RE: Blythe Solar Power Project, Docket No. 09-AFC-6
Responses to January 15 and 20, 2010 CEC Email Query from CEC staff, Additional Information regarding
Transmission System Engineering.

**Responses to CEC Email Requests,
January 15, 2010
Transmission System Engineering**

Blythe Solar Power Project

Data Response Queries – January 15, 2010

Figure 2-8

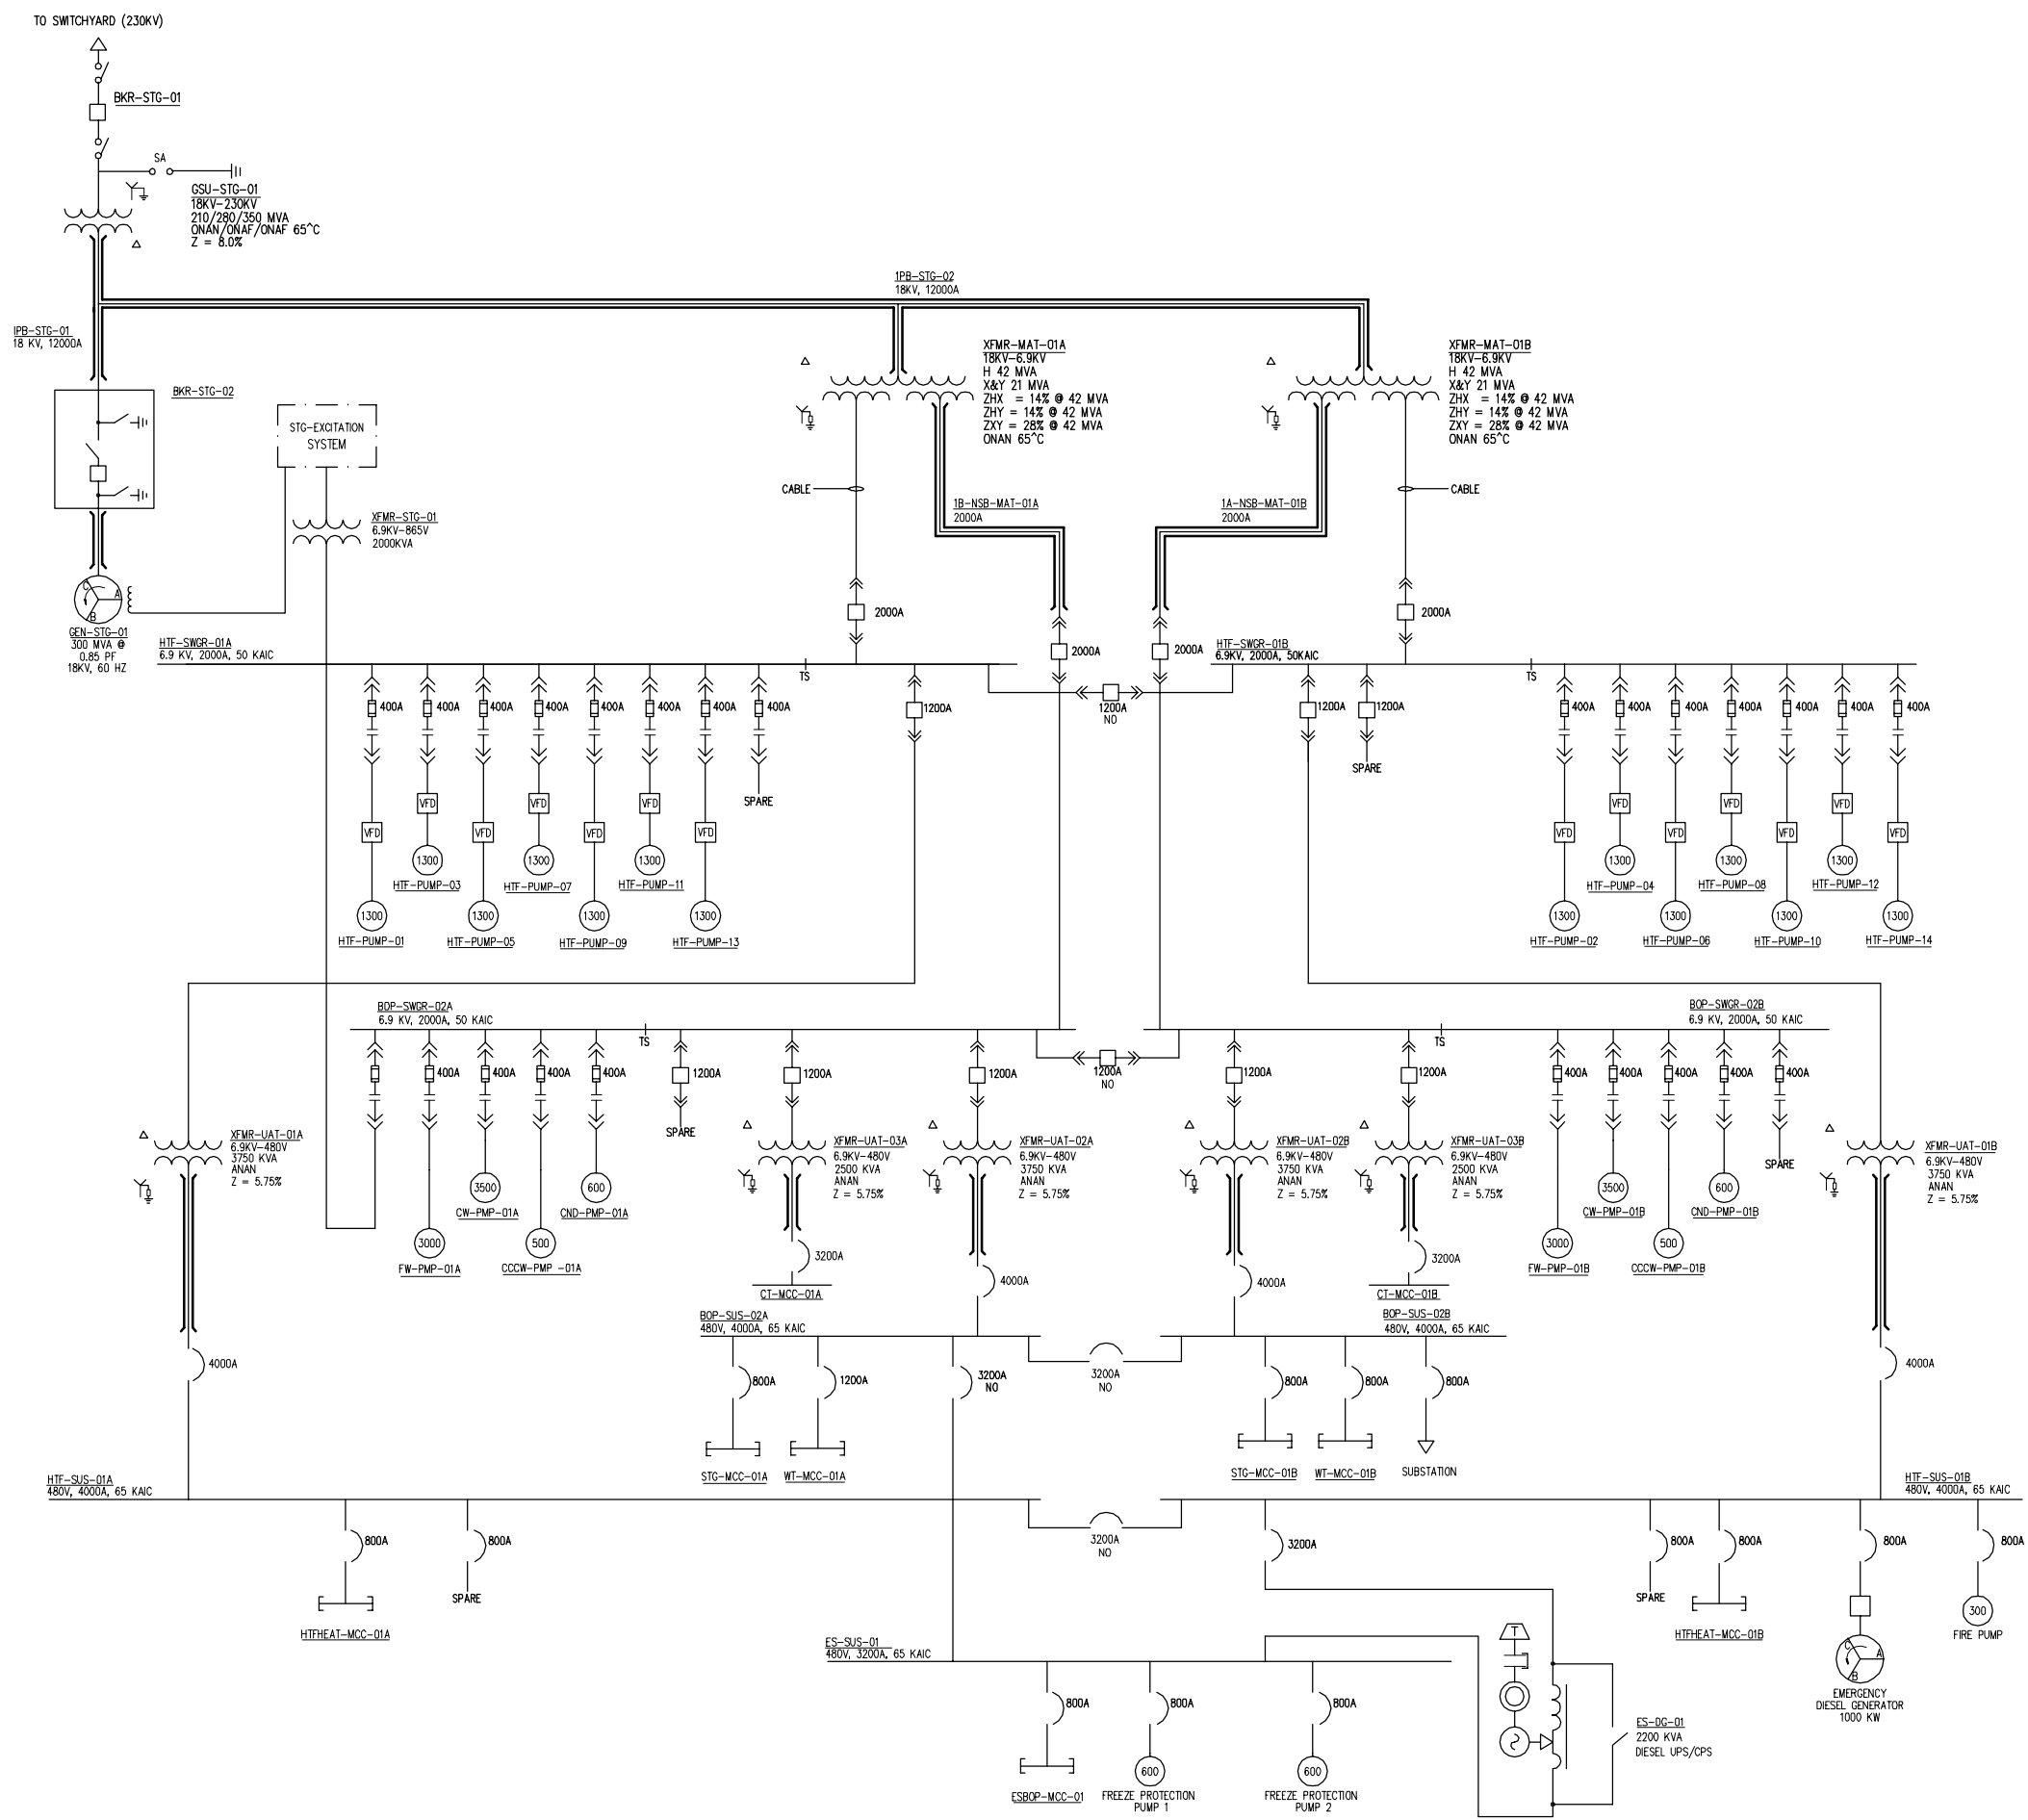
6) Please update Figure 2-8 (Conceptual One Line Diagram - Power Plant).

The revised Figure 2-8 is provided as an attachment to this submittal.
